**c. Table 5.4.1 – Minimum Area and Dimension Controls for New Lots**

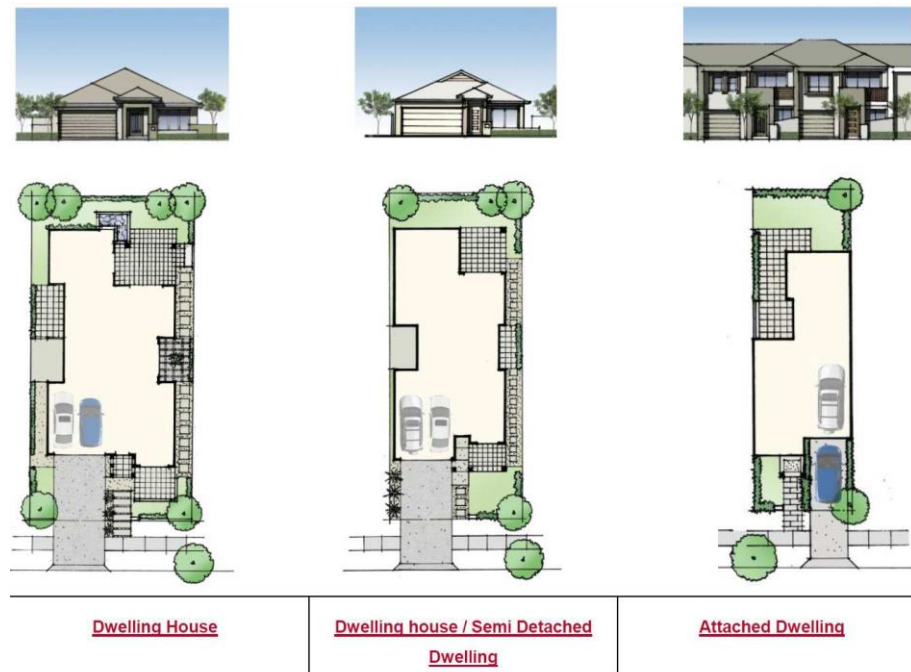
- i. Table 5.4.1 *Minimum Area and Dimension Controls for New Lots* within Section 5.4 *General Subdivision Controls* makes reference to Semi-detached Dwellings being able to be re-subdivided (in accordance with Part 5.11). The re-subdivision of this type of housing is not supported and is considered inconsistent with Section 3.2 of the Code, whereby such housing type relates “...*specifically to one dwelling on a single lot*”, unless the allotment is large enough to accommodate the minimum lot size and dimensions for another housing product.

- ii. Table 5.4.1 nominates a minimum lot size for Attached Dwellings as 100m<sup>2</sup>. This is not supported given that the minimum effective lot width (5m) and the minimum lot depth (30m) results in a minimum lot area of 150m<sup>2</sup>. It is also noted that the Table requires a minimum 125m<sup>2</sup> building envelope.

**Comment: Further justification as to why the resubdivision of Semi-detached Dwellings is not permitted if the lot area allows for this to occur is requested. Appropriate easements or relocation of services either within the dwelling or external will need to be considered and registered.**

**Comment: Amended, the minimum lot size has been increased to 225m<sup>2</sup>.**

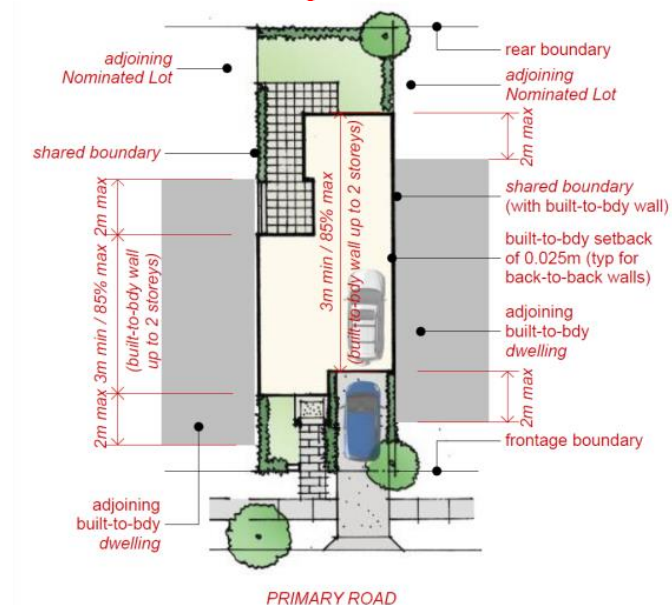
- iii. The proposed 5m wide front access for Attached Dwellings is not supported, unless a rear lane access is provided. The proposed 5m lot width also results in a development not being able to achieve the on street parking requirements noted in Table 5.4.1. As shown in the image below (Page 113 of the Track Changes Code), a driveway at the front of the allotment would not provide sufficient on street parking if a 5m frontage is proposed for this type of development.

Comment: The minimum frontage width has been amended to 7.5m minimum and the required onstreet parking has been altered to 0.5 spaces. This is considerate of the practicality of the dwelling type where by they are likely to be mirrored allowing both dwelling to provide for 1 space on the street. A note has also been provided to permit the required onstreet parking to be within 100m of the frontage. As per table 2.2.14.1 Attached Dwelling requires minimum of 2 spaces with 1 space to be covered internal of the lot. Figure 2.2.7.1 illustrates that two spaces can be provided on the site with one space covered.
